GAROB DEVELOPMENTS LIMITED

PROPOSED CHANGE OF USE, FROMER CO-OP, WELL STREET, CEFN MAWR, WREXHAM

TN03 – RESPONSE TO LHA COMMENTS

4TH JULY 2023

APPENDIX 1 – PROPOSED SITE LAYOUT

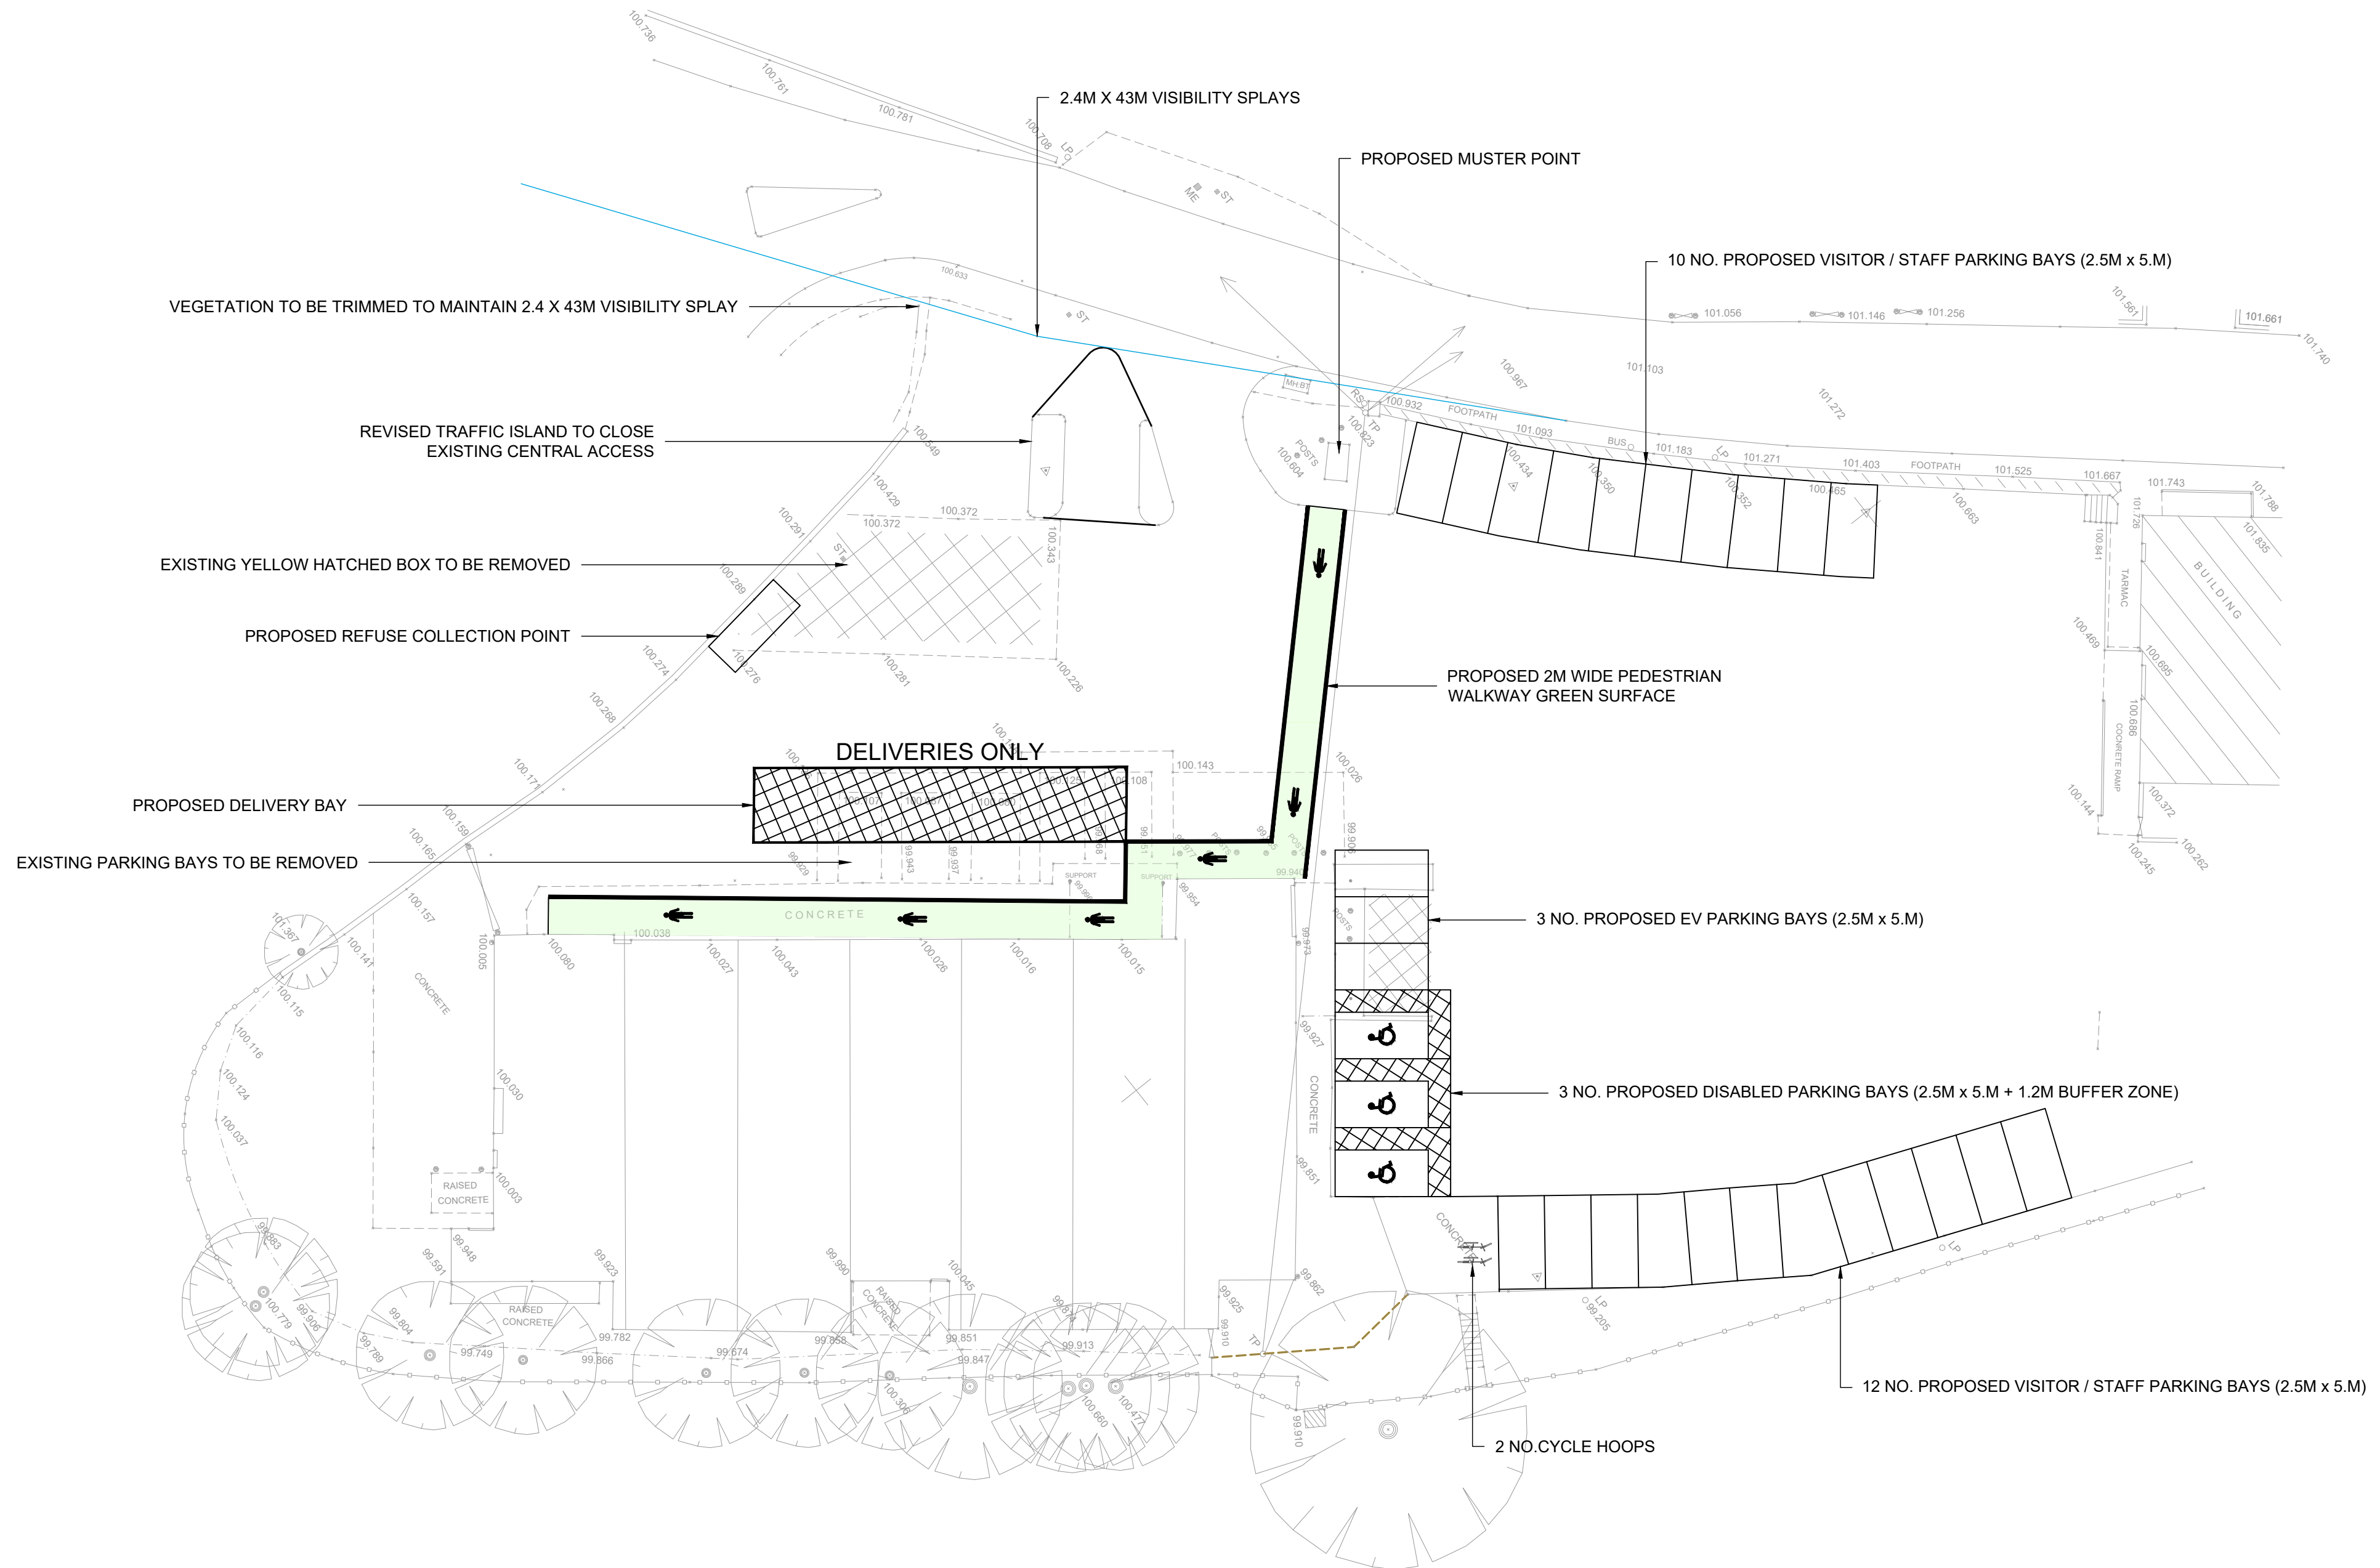
- 3.1 The following comments by the LHA refer to the additional information provided by Connect as part of the previous correspondence: *"As discussed, we are comfortable with the additional information provided, subject to the following qualifications:"*
- 1. The scrub/weeds to the right of the entrance can be removed and maintained to below 1m high, and a plan will be provided showing visibility splays each way. I know the junction quite well and am comfortable that with this improvement, visibility will be well within requirements for a 20mph speed limit in place on Well St.*

2. Swept path analysis has been provided for both articulated and rigid HGV's both of which are permitted under the current site classification. We note our agreement that adjustment to the central islands may be necessary, which we can agree in due course via a pre-commencement condition as noted below. These alterations may provide central refuge to pedestrian traffic given the size of the opening.

- 4.1 The following comments by the LHA refer to their request for a proposed layout plan: *"We would request that any approval is conditioned to provide a detailed coordinated layout showing the following prior to commencement on site:"*

1. On-site vehicular parking for staff and customers, and any third party spaces for commercial premises along the north east boundary (if applicable). Proposals and layout needs to comply with LPG16.

2. Deliveries and servicing of the proposed premises

3. Safe pedestrian movement both across the entrance and across the site, compliant with DDA and Active Travel Requirements Wales.

4. Adequate lighting

5. Refuse Collection

6. Consideration for Electric Vehicle Charging

7. Any muster points in case of emergency

8. Surface water drainage and demonstration that no surface water will discharge onto the public highway.

9. Hard landscaping proposals detailing materials and markings

10. Secure bike parking proposals

- 3.2 The proposed site plan provided at Appendix 1 shows visibility splays of 2.4m x 43m on the site access approach, which complies with the requirements set out in Manual for Streets 2 for roads subject to a 20mph speed limit. Vegetation will be managed to maintain these splays.

- 3.3 The proposed site plan shows that the existing central access will be closed to form one refuge island, which will provide a central respite area, and allow for shorter crossing distances across the access.

- 4.2 The parking spaces shown on the proposed site layout at Appendix 1 have been provided with reference to the parking standards in LPG16.

- 4.5 The proposed site layout shows 28 parking spaces, which accords with the maximum standards for B1 business use.

- 4.7 The proposed site layout shows a marked pedestrian route along the building's western frontage, which extends across the car park to the footway on the north side of the access.

- 4.8 The car park and turning area will be illuminated to a minimum of 20 lux as informed by the BS EN 12464. The proposed site plan includes a note confirming this.

- 4.9 Refuse collection is proposed to take place within the site at the refuse collection point on the southern boundary of the site, which is identified on the proposed site plan. Refuse vehicles will be able to manoeuvre within the site to undertake this, which is demonstrated by the swept path analysis at Appendix 2.

- 4.10 WCBC do not provide a standard for EV charging provision and so reference has been made to Policy 12 of the Future Wales: The National Plan 2040 report, which states that planning authorities should seek a minimum of 10% of parking spaces to have electric vehicle charging points. As such, three of the proposed 28 spaces will have electric vehicle charging capability, equating to 10% of total provision and thus according with the national standards.

- 4.11 A muster point is located at the area of private footway at the northern radius of the site access, which is identified on the proposed site plan.

- 4.12 The site plan shows decreasing levels at the site access away from the highway, such that surface water in the site will discharge to the rear of the site and not onto the highway.

- 4.13 The proposed car parking spaces and landscaping alterations are shown on the site plan at Appendix 1.

- 4.14 The cycle parking standards set out in LPG16 for business / storage and distribution use are as follows:
- B1 Business and Light Industry – minimum of 1 space per 300 sq.m. GFA.
 - B8 Storage and Distribution – minimum of 1 space per 1000 sq.m. GFA.
- 4.15 The above equates to a minimum of 1 to 3 cycle spaces, depending on use ($850 \div 300 = 2.8$; $850 \div 1000 = 0.9$).
- 4.16 The proposals include 2 Sheffield-type cycle stands, capable of securing up to 4 cycles, which exceeds the minimum standards.
